**[Docket No. FAA-2020-0098; Product Identifier 2020-NM-011-AD; Amendment 39-19844; AD 2020-03-20]**

#### **Airworthiness Directives; The Boeing Company Airplanes**

**ACTION:** Final rule; request for comments.

Figure 2 to paragraph (g) – AFM – Limitations or Certificate Limitations continued

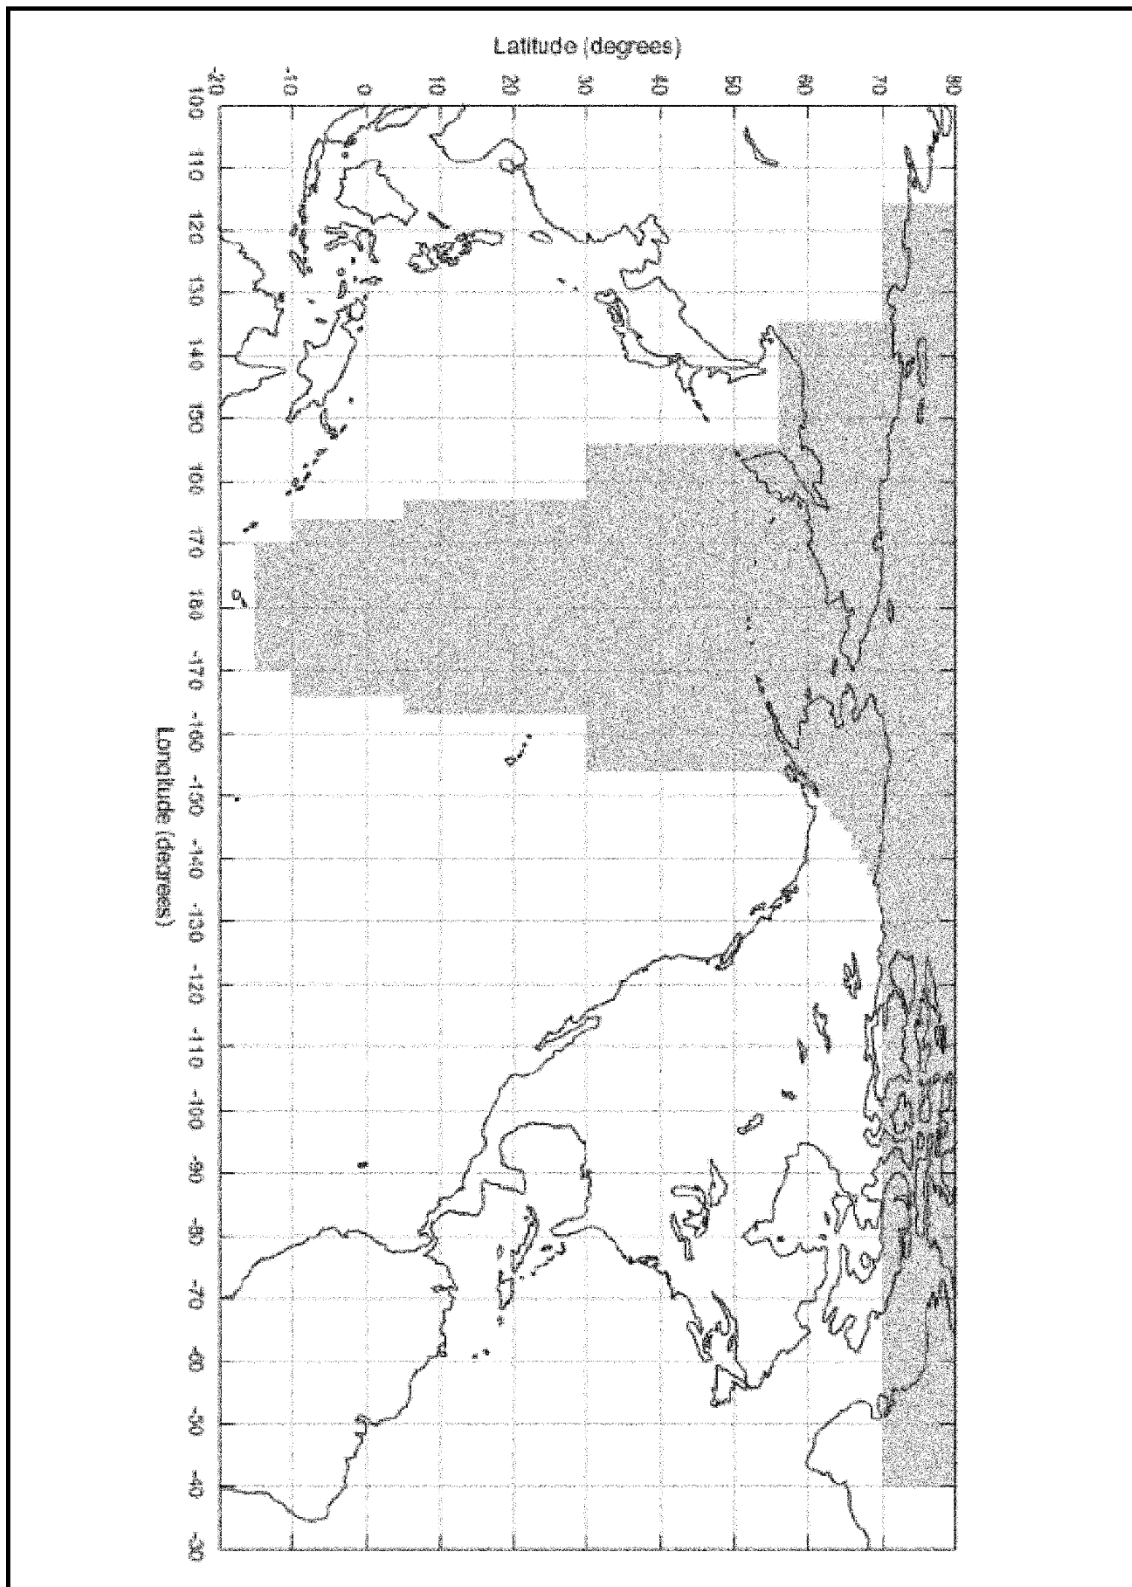
Operations that require less than 0.3 RNP (For example, 0.1, 0.11, 0.15, etc.) in the region identified below are prohibited with GLU-2100 OPS software number COL4D-0087-0002, COL4E-0087-0001, COL48-0087-0700, or COL49-0087-0701 installed.

Exception: Anchorage (PANC) approach procedures that allow less than RNP 0.3 are authorized provided the instructions outlined in the Electronics – Global Landing Unit Section of Normal Procedures Chapter are followed.

Note: Currently, Fairbanks (PAFA) and Anchorage (PANC) are the only airports in the region with an RNP approach that requires better than 0.3 nmi performance.

Region bounded by the following coordinates:

For airplanes equipped with Collins GLU-2100 MMR, part number (P/N) 822-2532-100, having any applicable GLU-2100 operational software (OPS) identified in figure 1 to paragraph (g) of this AD installed: At the applicable time specified in paragraphs (g)(1) and (2) of this AD, revise the limitations or certificate limitations section, as applicable, of the existing AFM to include the information specified in figure 2 to paragraph (g) of this AD and revise the procedures or normal procedures section, as applicable, of the existing AFM to include the information specified in figure 3 to paragraph (g) of this AD. This may be done by inserting a copy of figures 2 and 3 to paragraph (g) of this AD into the existing AFM.
